Access Compliance Report Public Rights-of-Way (Curb Ramps)

Intersection ID: N/A Main Street: S CALDWELL ST Cross Street: E STONEWALL ST Location: S

Overall Compliance: No Severity Score: 0 ADA ID: D90D915CEEB1 Ramp Type: BlendTrans1 Initial Pass/Fail: Pass

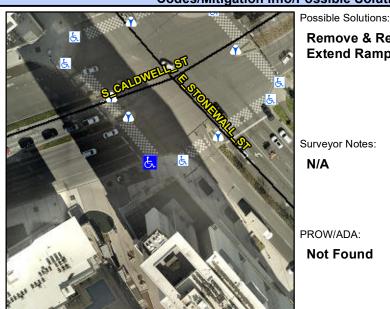
Yes Storm Grate/Utility Hazard? No Storm Grate/Utility Type N/A Yes Surface Condition? (G/P) Good No Curb Slope (%) 9.2

Remove & Replace Curb Slope and

Extend Ramp.
